BEFORE THE ARIZONA CORPORATION COMMISSION

BOB STUMP		
Chairman		
GARY PIERCE		
Commissioner		
BRENDA BURNS		
Commissioner		
BOB BURNS		
Commissioner		
SUSAN BITTER SMITH		
Commissioner		
IN THE MATTER OF THE APPLICATION)	DOCKET NO. W-02113A-13-0118

OF CHAPARRAL CITY WATER COMPANY

DIRECT

Figure 4 Water Use

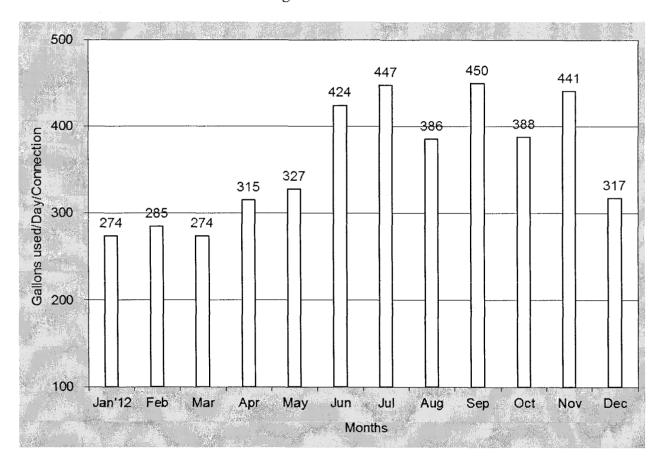
Figure 4 represents the water consumption data provided by the Company in its revised water use data sheet⁷ for the test year ending December 31, 2012. The Company customer consumption included a high monthly water use of 450 gallons per day ("GPD") per connection in September, and the low water use was 274 GPD per connection in January and March. The average annual use was 361 GPD per connection.

Staff recommends that the Company ensure the accuracy of all meters in its water system (including meters indicating gallons purchased/pumped) and be required to report accurate information in its Water Use Data Sheet in future Annual Reports and other fillings.
